January 21, 2014

Middle and Lower Chase River Dams Progress Update

Hydrology Study Review

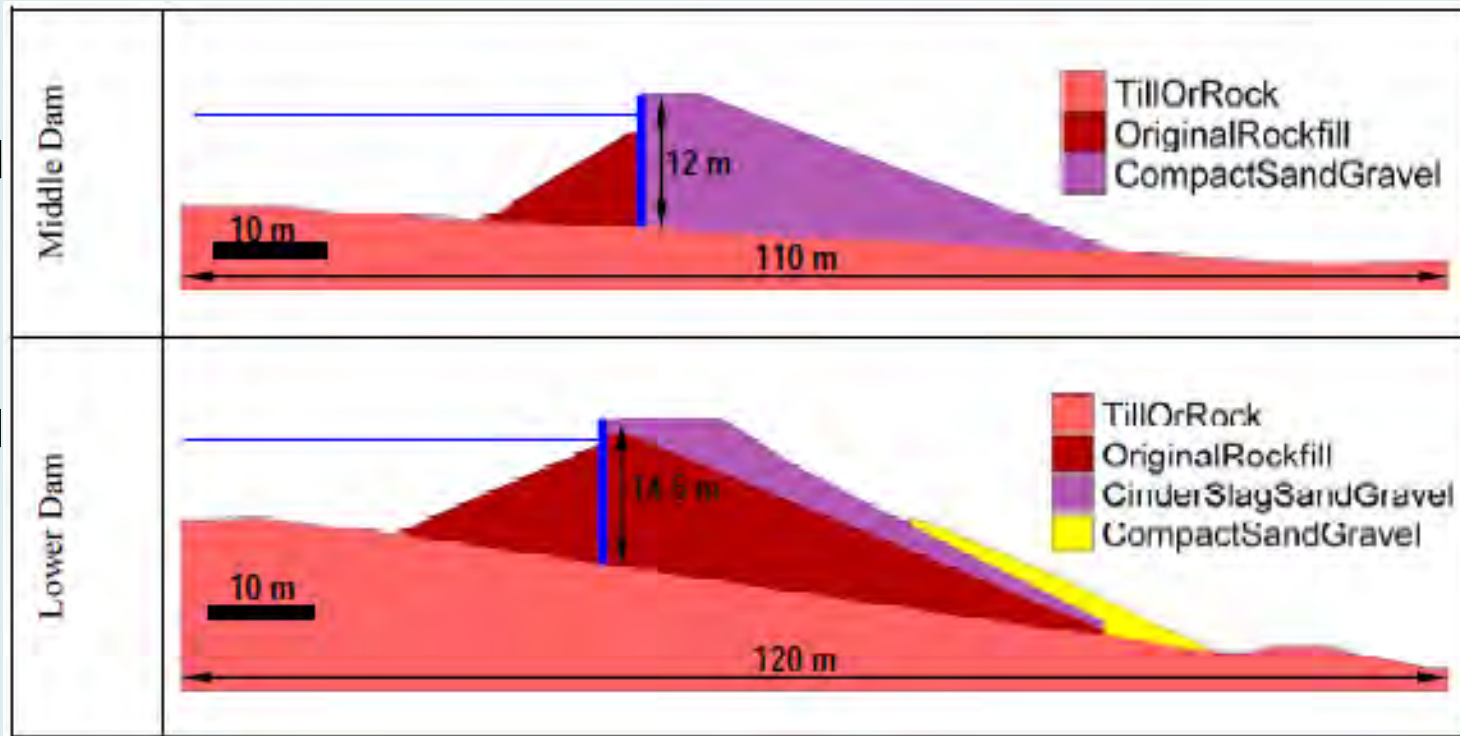
available for
Rock Fill,
Sand/Gravel and
Cinder/Slag.
The dam till-like
foundation
parameters used
for analysis not
clear

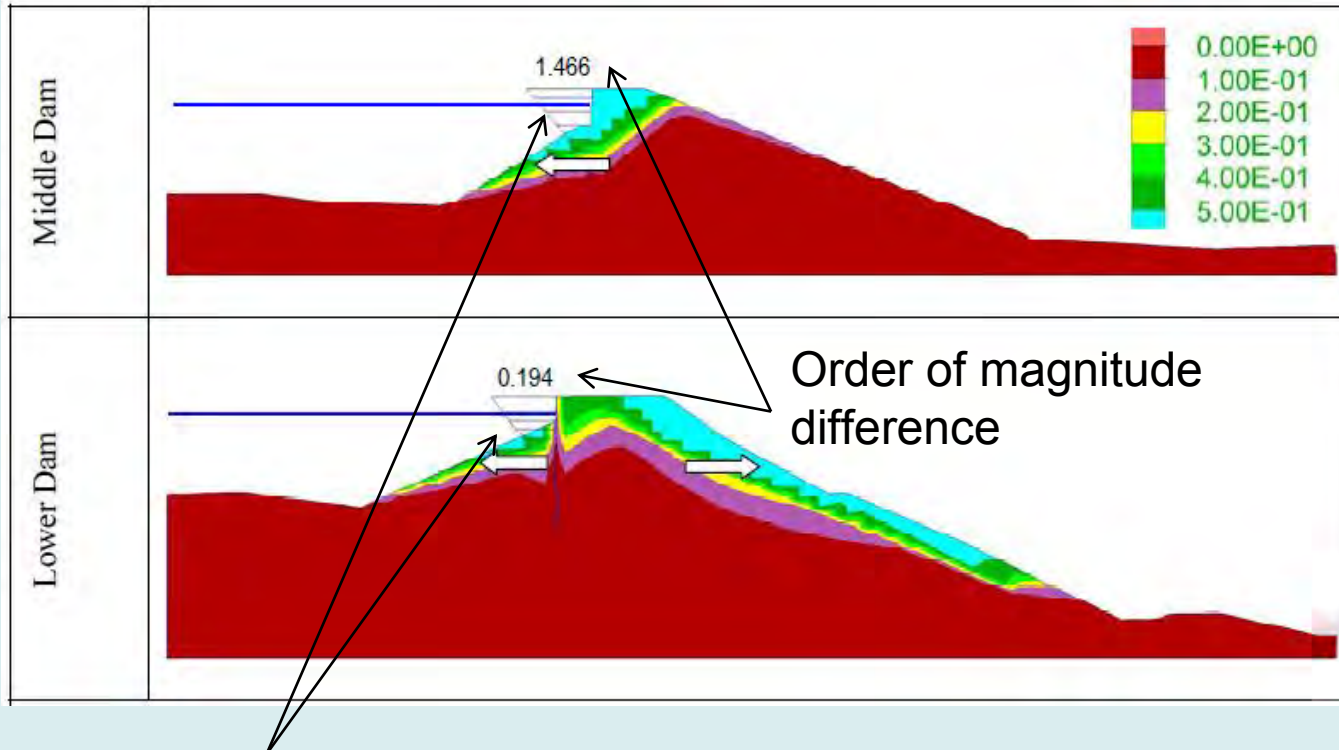
- No concrete/ soil interface taken into account
- Cracking of the concrete core requires further study
 - Does cracking of the concrete core = failure?

- The dam may be damaged in an earthquake with lower excitation levels (return-period) that was not investigated by EBA fully

Figure 2.1 - Chase River Watershed

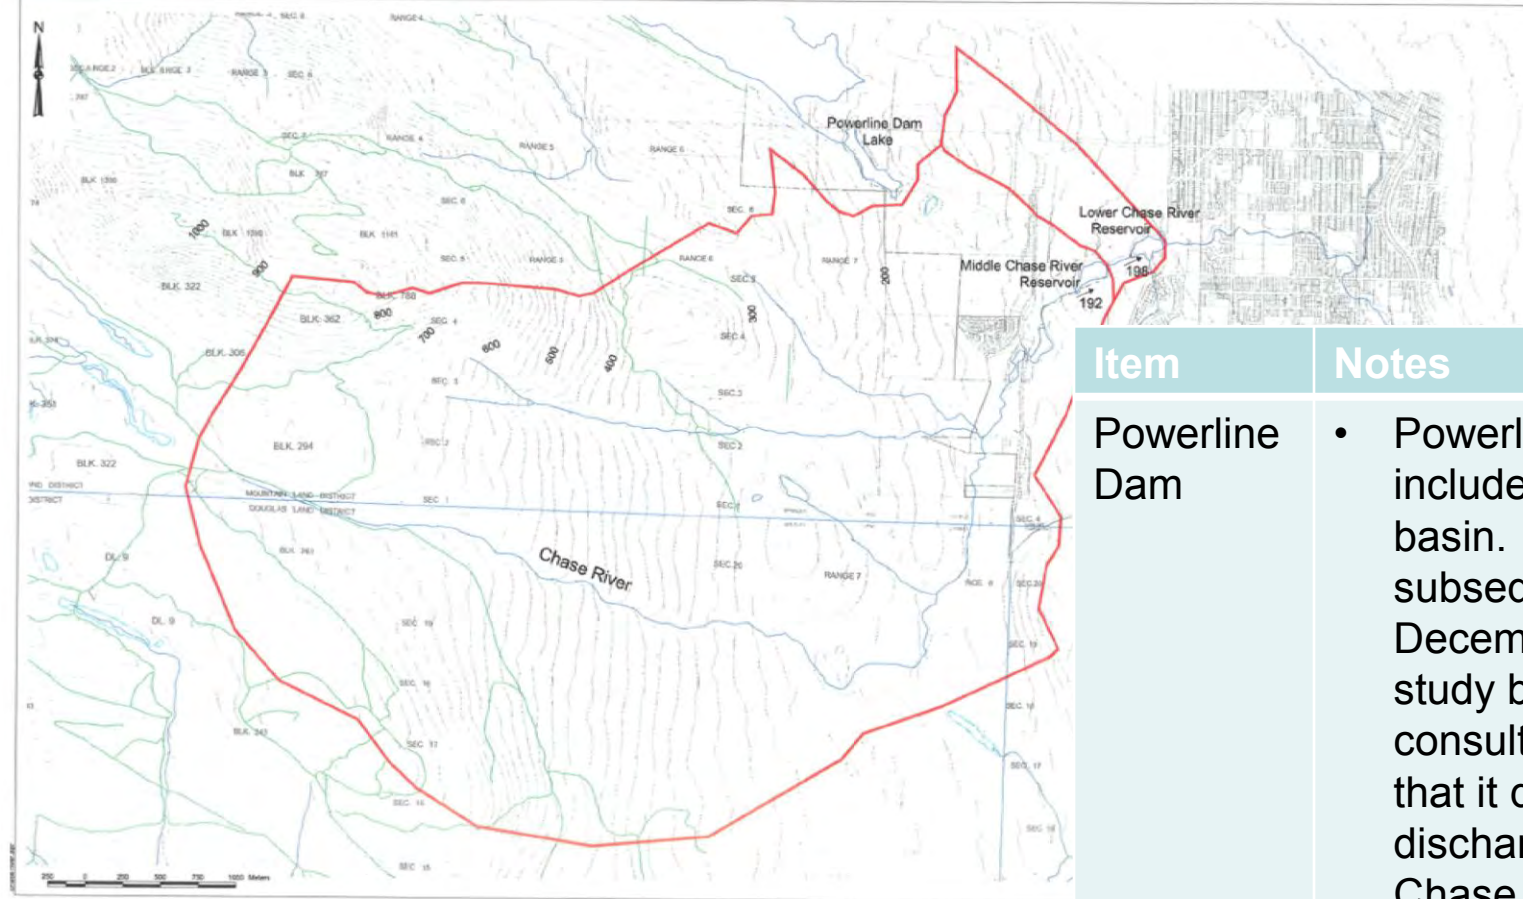
- Powerline dam not included in drainage basin. However, subsequent December 17, 2002 study by the same consultant indicates that it does discharge into the Chase River basin.
